**SECTION 16 APPLICATION
TOWN PLANNING ORDINANCE (CHAPTER 131)**

Town Planning Application No. A/YL-NSW/348 - Submission of Further Information (5)

**PROPOSED SOCIAL WELFARE FACILITIES (RESIDENTIAL CARE HOME FOR THE DISABILITIES (RCHD)) IN “VILLAGE TYPE DEVELOPMENT” ZONE, VARIOUS LOTS IN D.D. 104 AND ADJOINING GOVERNMENT LAND, NAM SANG WAI, YUEN LONG
(APPLICATION NO. A/YL-NSW/348)**

SEWERAGE IMPACT ASSESSMENT

**PROPOSED TERMINAL MANHOLE AND
CONNECTION**

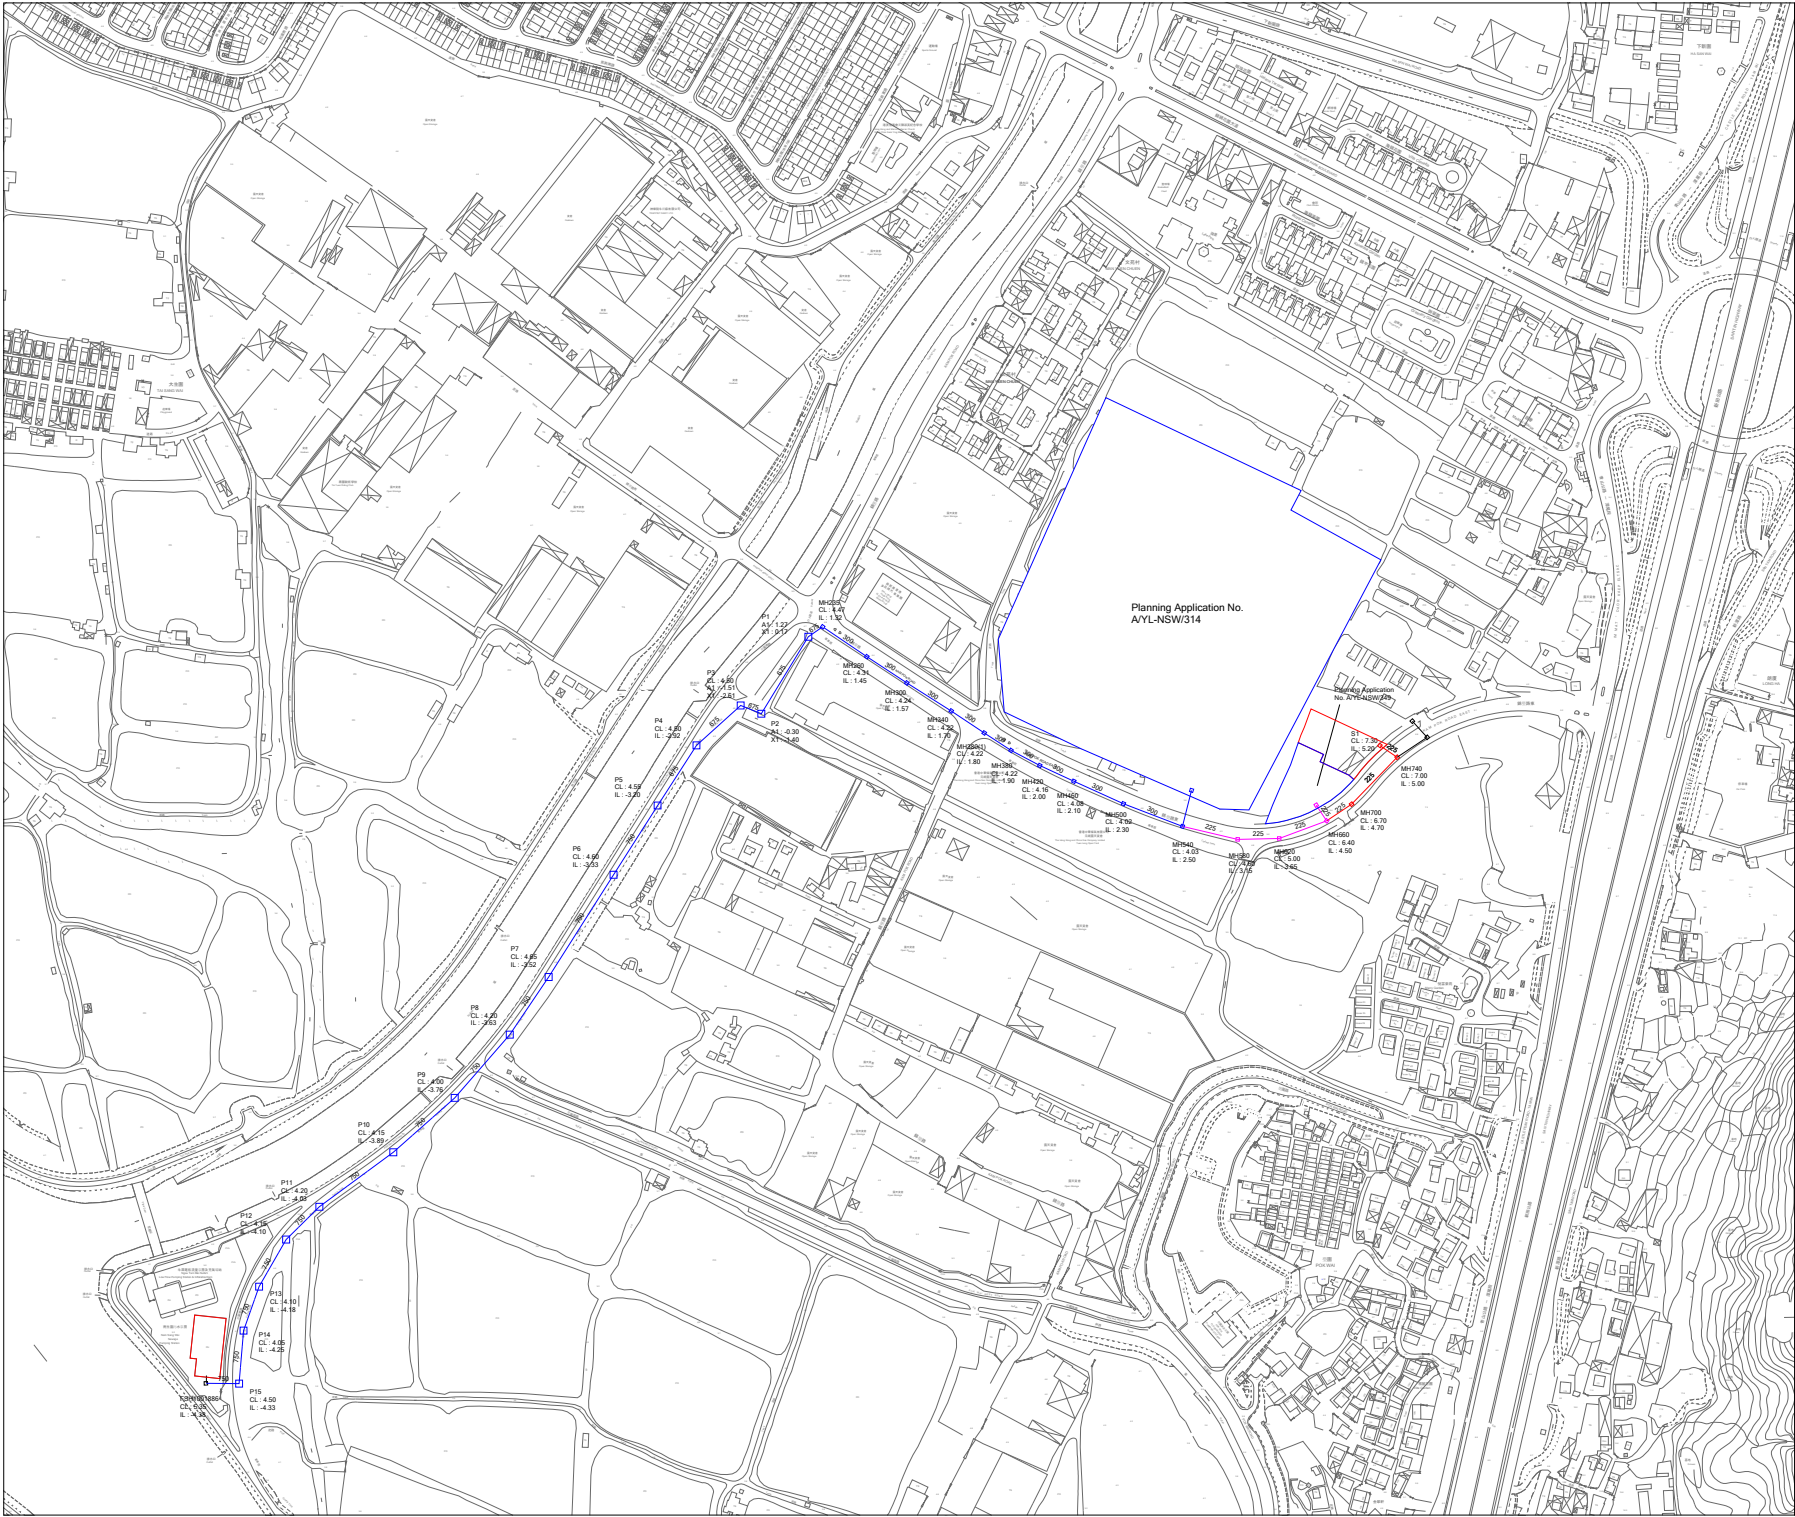
2. Sections 2.3-2.5: The applicant should clarify the party who is responsible for implementation of the proposed sewerage facilities connecting manholes S1 and MH660.	The discussion has been provided in Section 2.4-2.5.

- 2.4.1. New terminal manhole (namely S1) and manholes MH700 and MH740 will be constructed to collect the sewage generated from the Proposed Development and connect to manhole MH660 via a new 225mm diameter sewer pipe. The location of the proposed connection are shown in **Figure 3**. The cover level of proposed terminal manhole should be higher than that of the downstream public manhole(s). The proposed new terminal manhole and 225mm sewer pipe within site boundary will be implemented and maintained by the Project Proponent, other proposed manhole and sewer outside site boundary will become a public sewage system serving multiple users and will be handed over to government for future maintenance. The capacity check of the sewer will start from the proposed terminal manhole S1. The proposed development would not have population intake before the sewerage infrastructure of the project is functionally connected to the public sewerage system by other development mentioned in Section 2.3.
